Re: Traffic Impact Analysis (TIA) Report  
Port Marigny Site  
DE Project No. 576-1000-01

We have reviewed the revised Traffic Impact Analysis developed by Hall Planning & Engineering, Inc. dated October 6, 2015 for the above referenced site. Below are comments or suggestions to consider for this report.

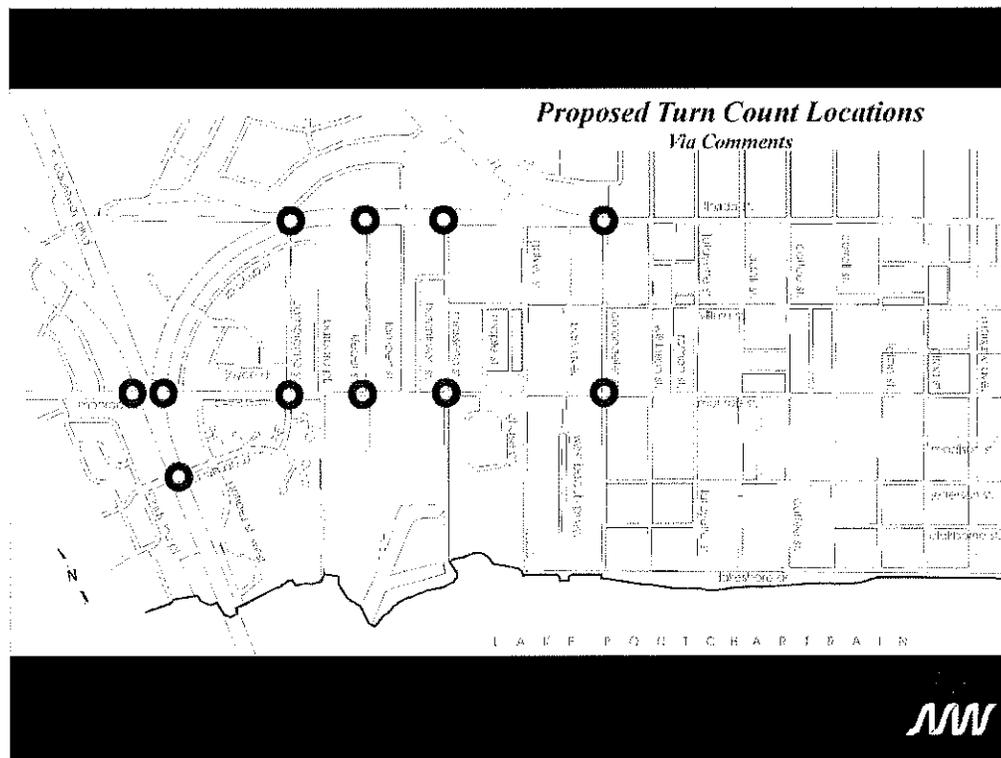
7. In the report, an intersection Level of Service (LOS) has been referenced to determine the effects of the proposed development. This basis of comparison is misleading because some approaches within the intersection may have a significant reduction in LOS whereas the effect to the intersection LOS is not as significant. For example, at the Monroe St. – E. Causeway Approach intersection, the intersection LOS changes from a level C (2015) to D (2025). However upon review of the Synhro computer output for this intersection's approach movements, the existing (2015) Monroe westbound left turn has a LOS of D with a 37.1 second/vehicle delay. But in the 2025 analysis the same approach is reduced to a LOS E with a 57.9 delay. Hence it would be our recommendation for remediation measures be considered or implemented for this movement at this intersection.

To properly evaluate the effects of this development to the adjacent roadway network, the report should review each movement, for both the AM and PM peak hour volumes, at key intersections, as shown in the following exhibit.

The TIA should provide exhibits showing pre and post-development LOS for each approach and movement at the key intersections
